AMERICAN TELECOMMUNICATION CORPORATION  
KIT FOR CUSTOM TELEPHONE  
INSTALLATION AND MAINTENANCE

1.01 This addendum is issued to provide the procedures for modifying Decorator Telephone Conversion Kit A-4200 for use with key telephone systems.

Figure 5. Wiring Diagram of Decorator Conversion Kit Wired for Use in Key Telephone System.

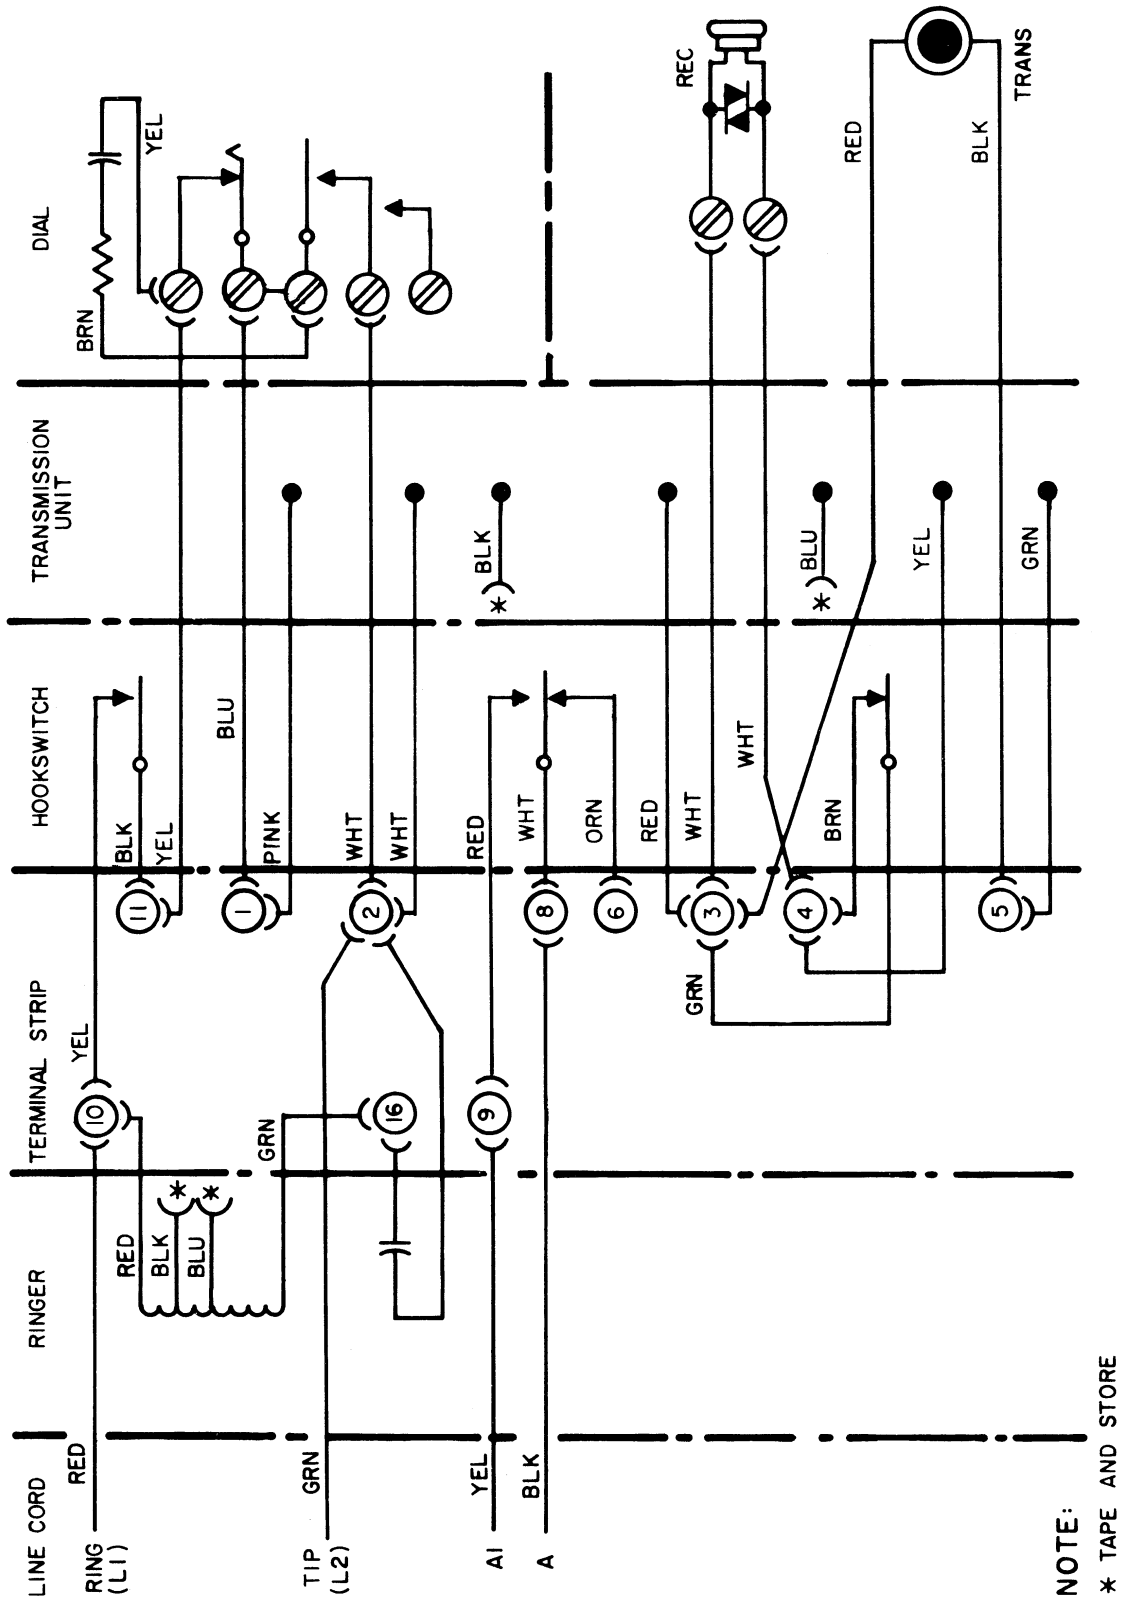
2.01 Add Part 5 and Figure 5 as follows:

5.01 To modify the conversion kit for use in key telephone systems, proceed as follows (Figure 5):

- (1) Remove the three-conductor line cord and replace with a four- or six-conductor line cord.
- (2) Connect the line cord to the terminals in the base as follows:
  - (a) RED (Ring) to terminal 10.
  - (b) GRN (Tip) to terminal 2.
  - (c) BLK (A) to terminal 8.
  - (d) YEL (A1) to terminal 9.
- (3) Move the ringer capacitor lead from terminal 9 to terminal 2.
- (4) Move the RED hookswitch lead from terminal 2 to terminal 9.
